**CITY OF SOUTHPORT
PLANNING BOARD
REGULAR MEETING AGENDA**

June 20, 2024
6:00 PM

MAJOR SITE PLAN MODIFICATION

Presentation Date	June 20, 2024 Planning and Zoning Board
Applicant	Aaron Schilling for Walmart #2772
Parcel ID	2210003103
Parcel Acreage	22.91 acres
Zoning District	HC – Highway Commercial

1
SD11
TREE PLAN
SCALE: 1" = 30'

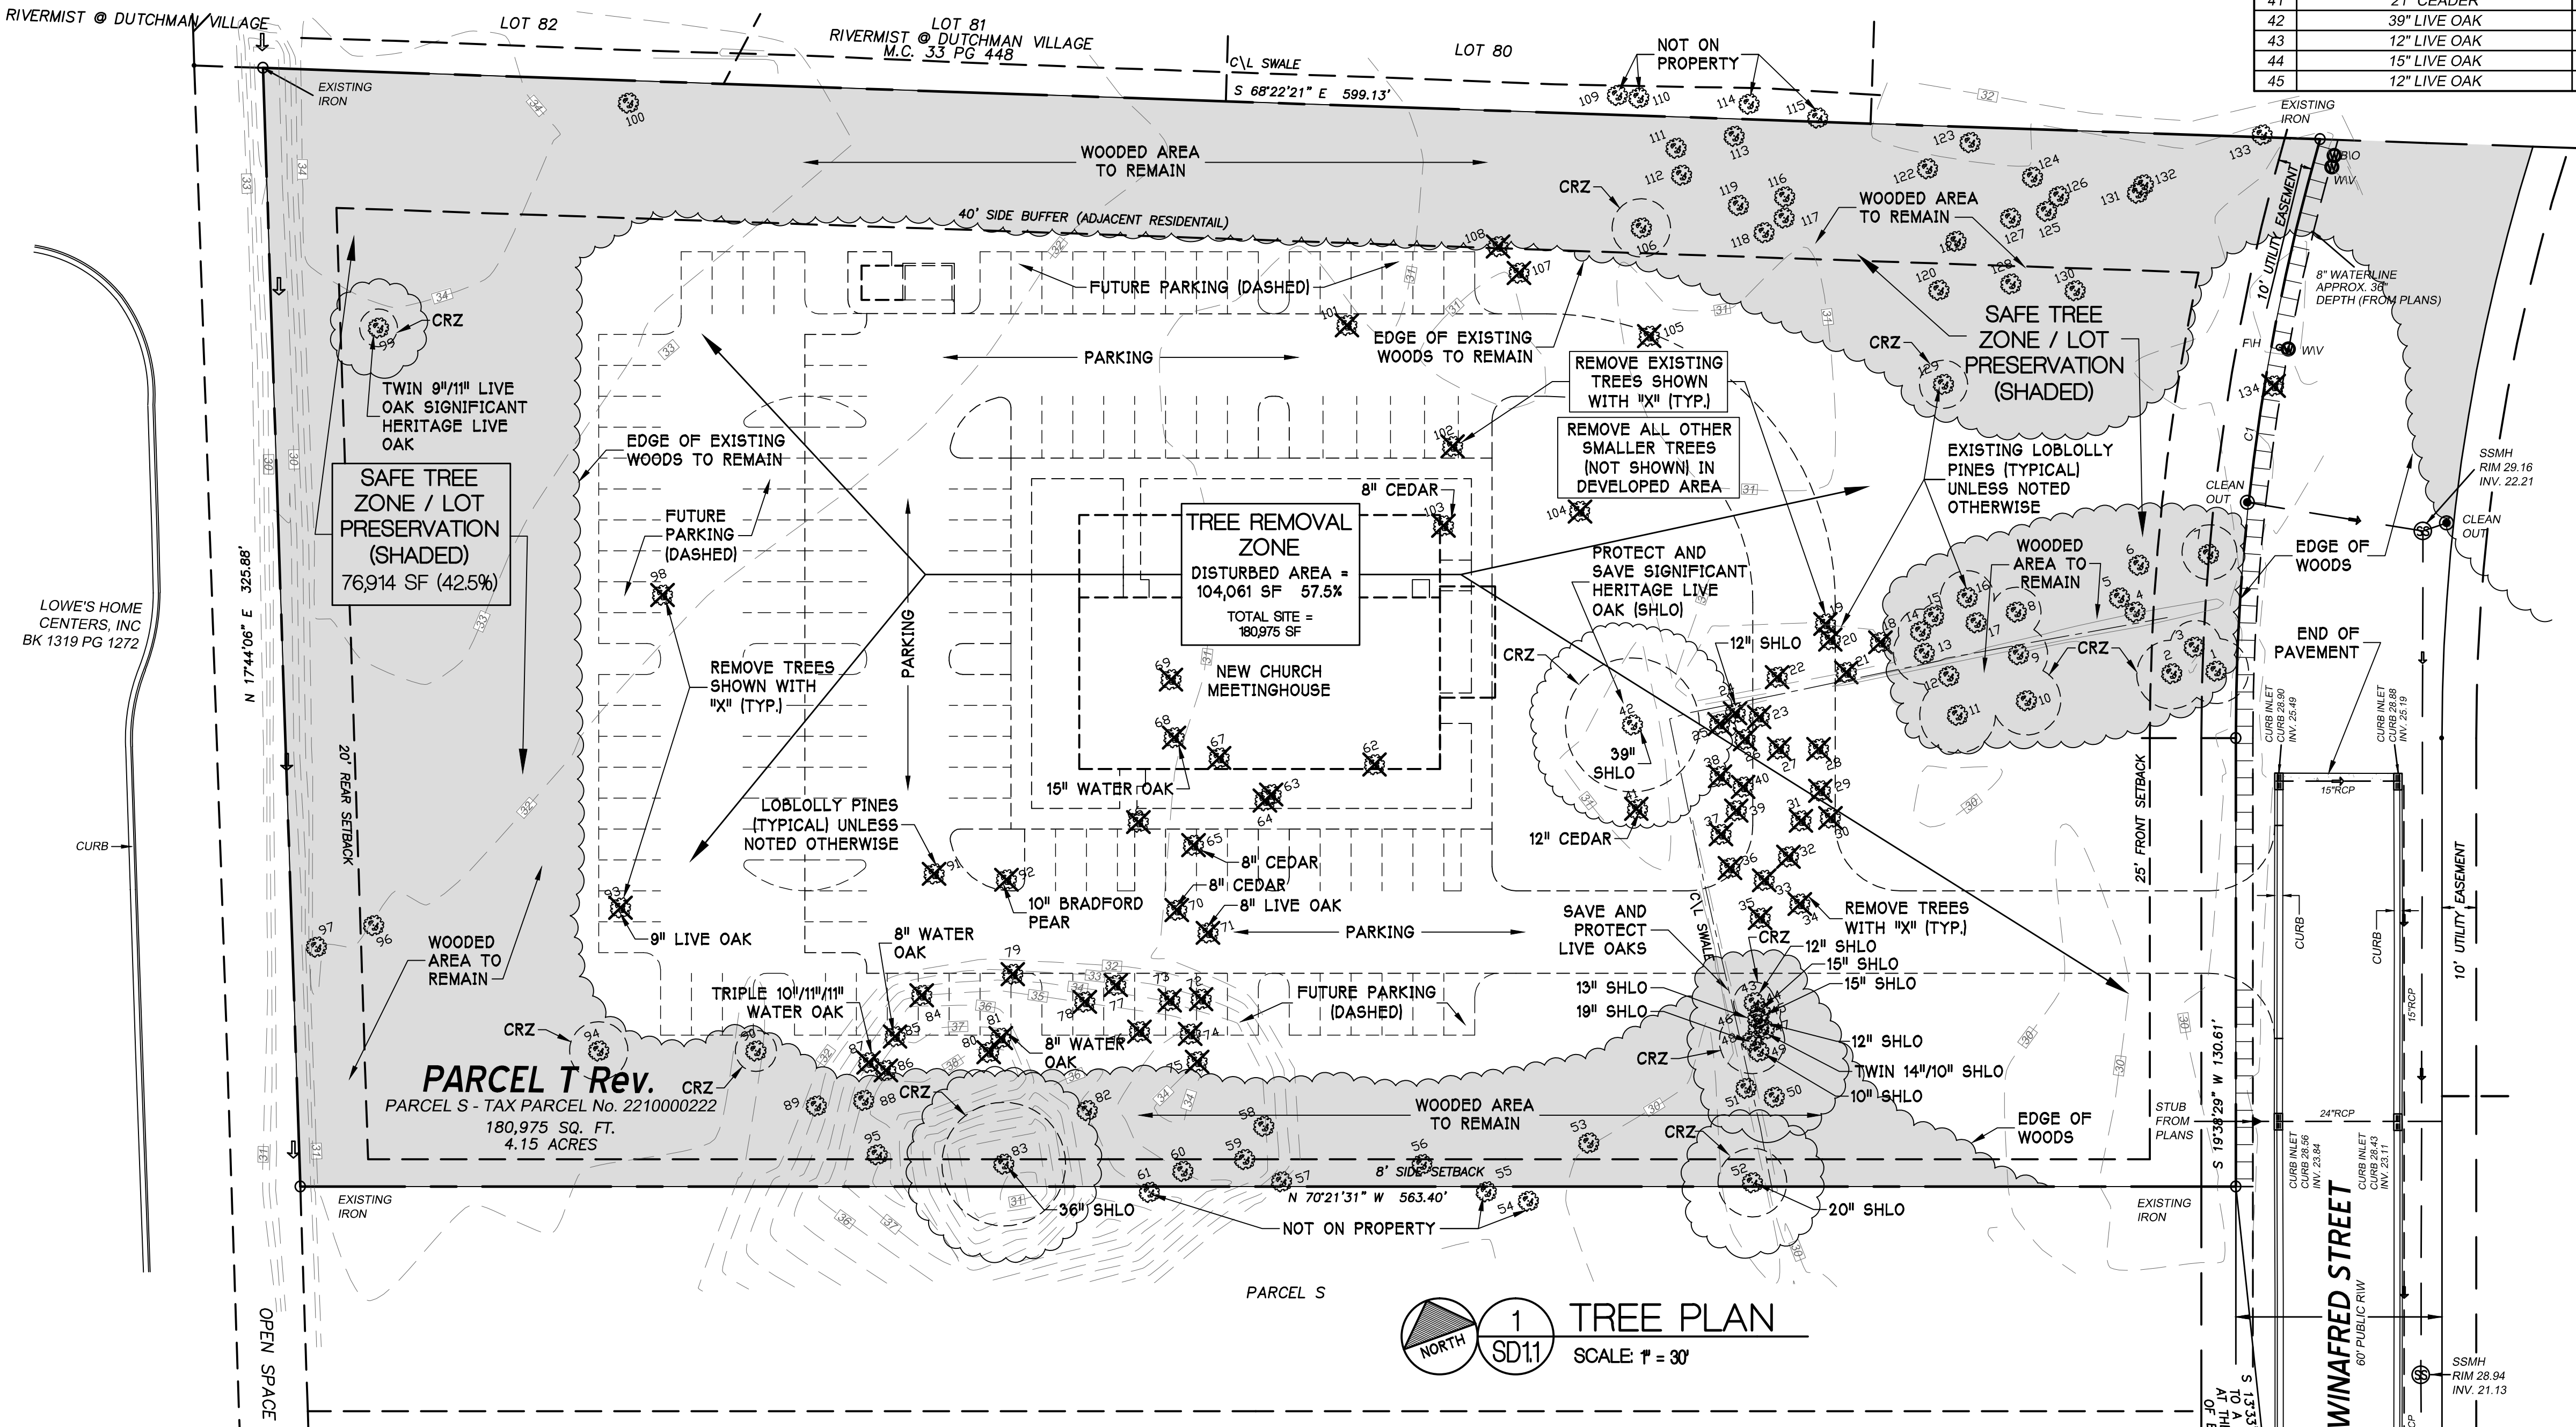
- Tree survey and mitigation are shown on sheet SD1.1.
14. Location, dimensions and spacing for parking lot landscaping complete. Please update for other required landscaping that meet Table 3.5 and 3.7 requirements.

1 ENGINEERING SITE PLAN
ESP1 SCALE: 1"=30'-0"

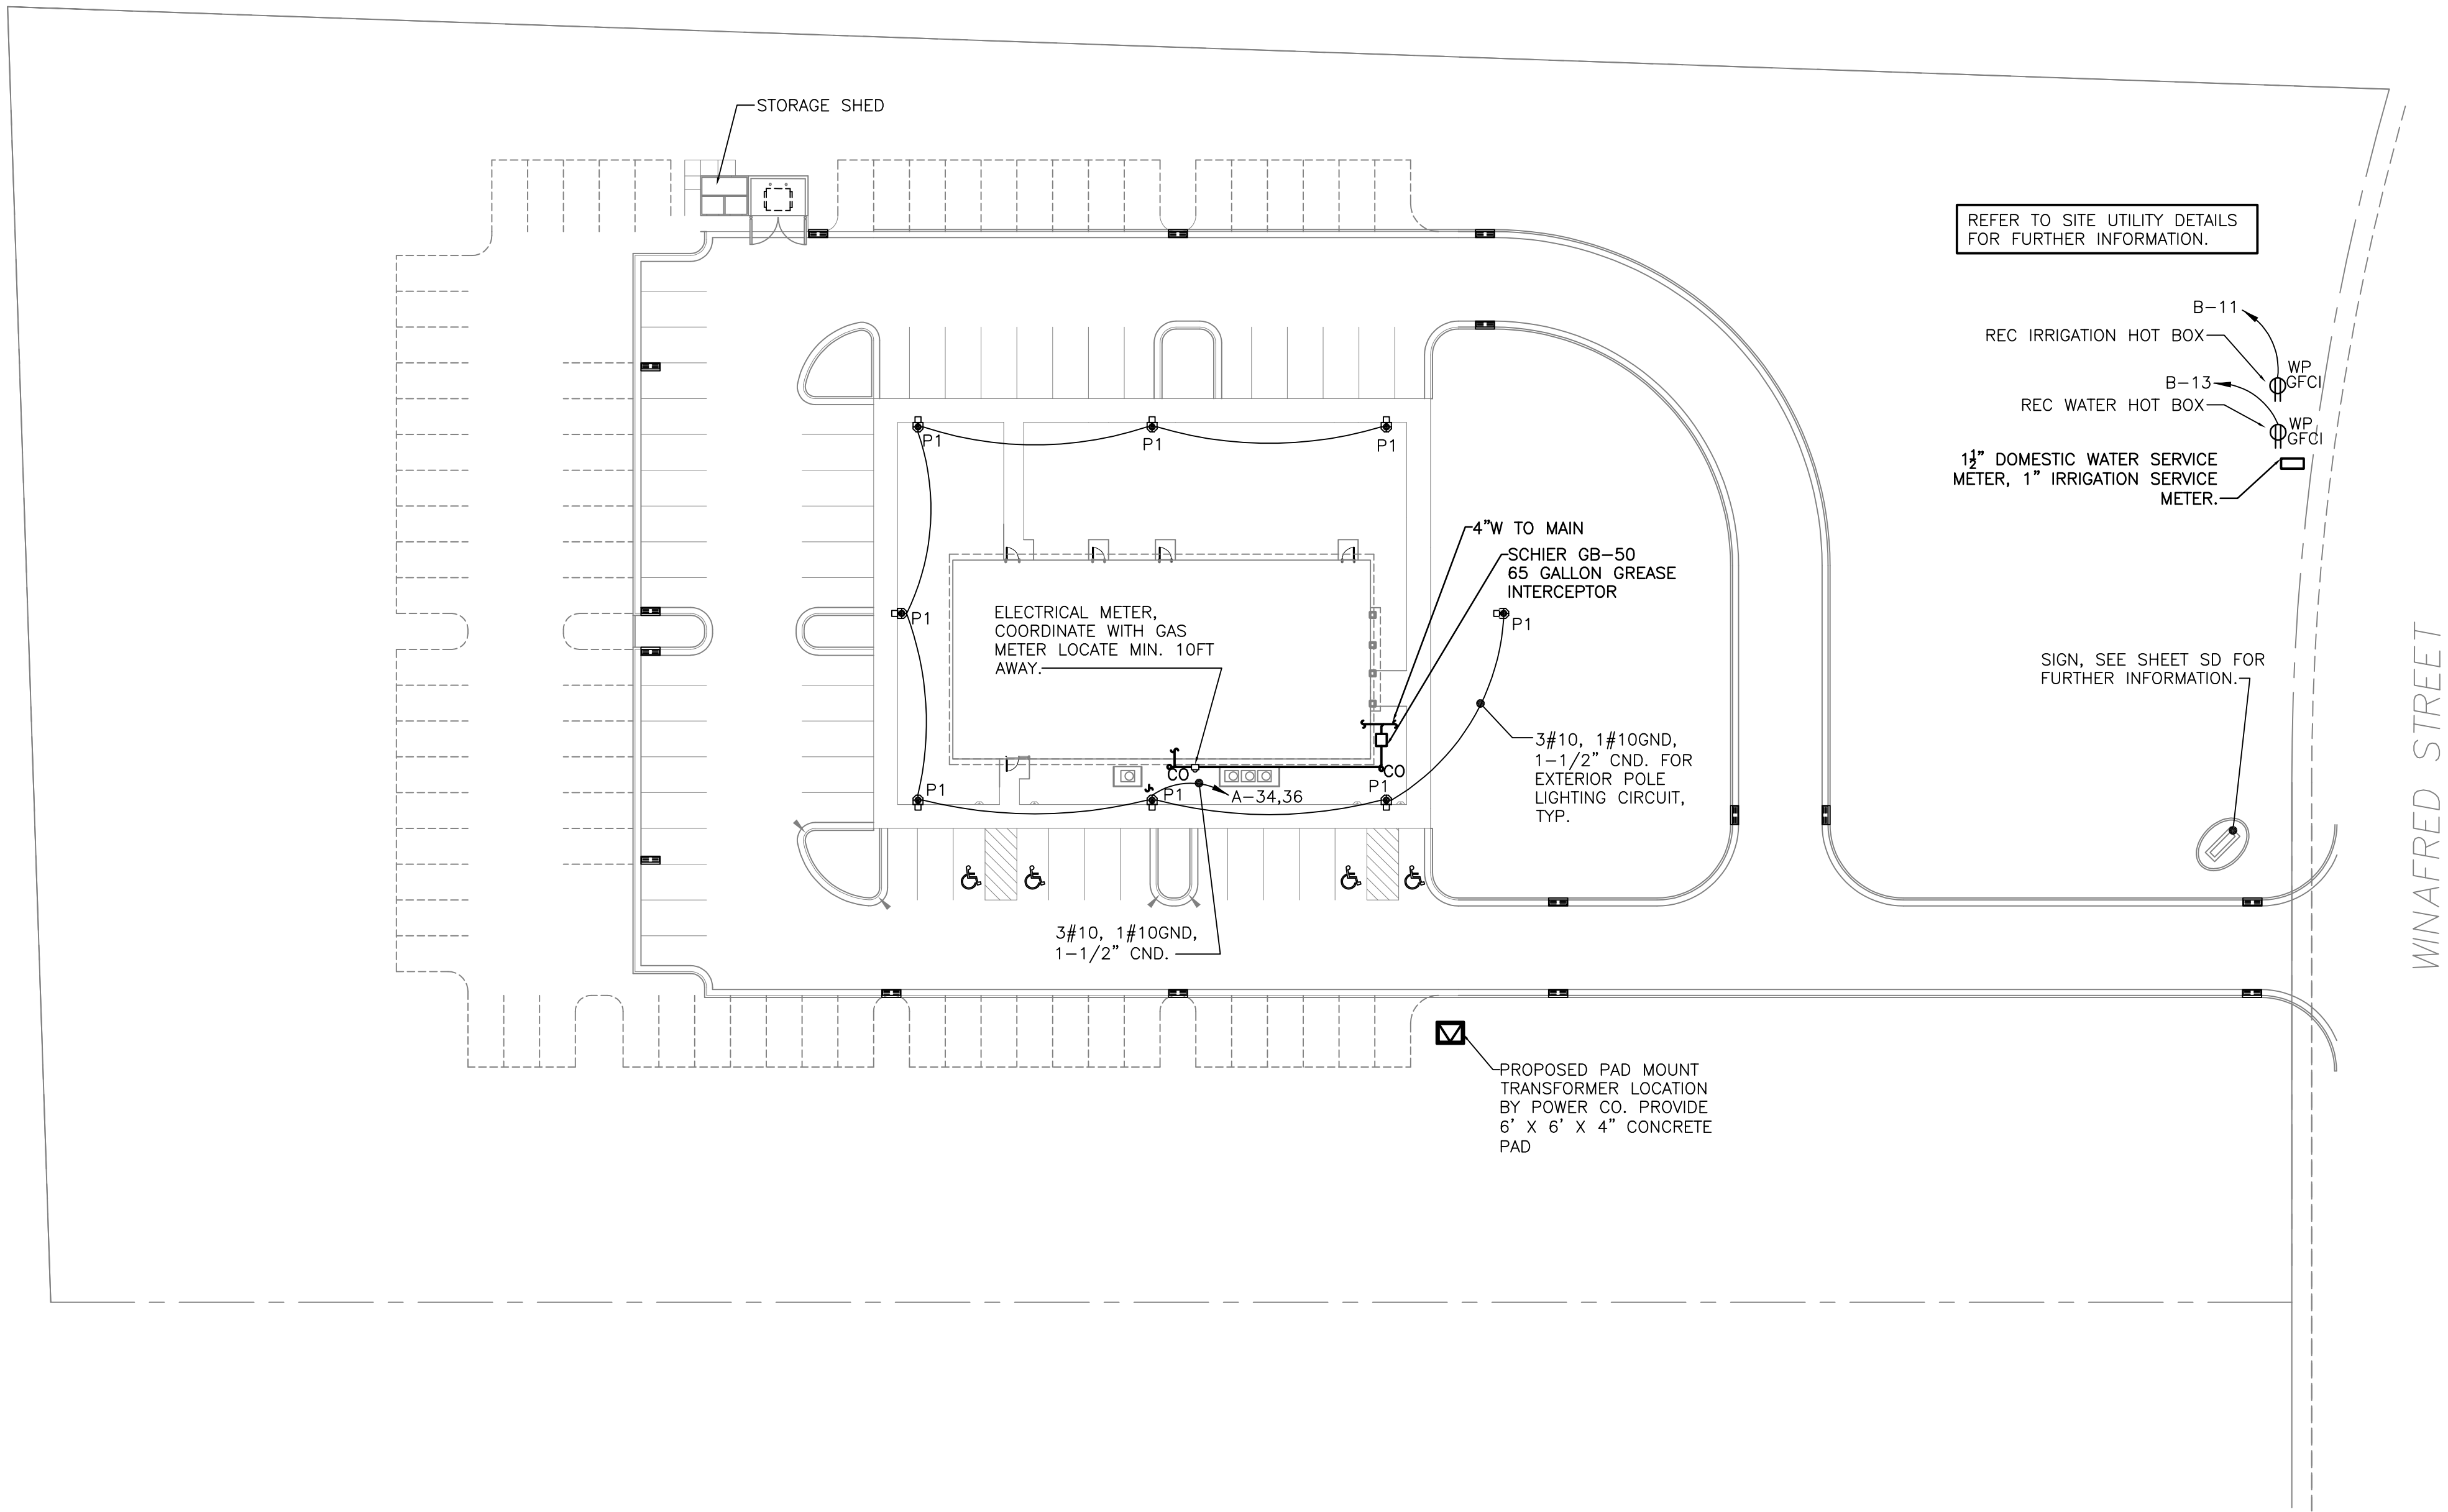
A lighting plan is attached on sheet ESP1. There are 8 lights proposed in the parking lot. The fixtures are 18' high on 36" concrete base with a light color temperature of 3000K. Maximum height for light fixtures is 40'. The lighting plan meets the standards of Section 3.16 of the City of Southport Unified Development Ordinance.
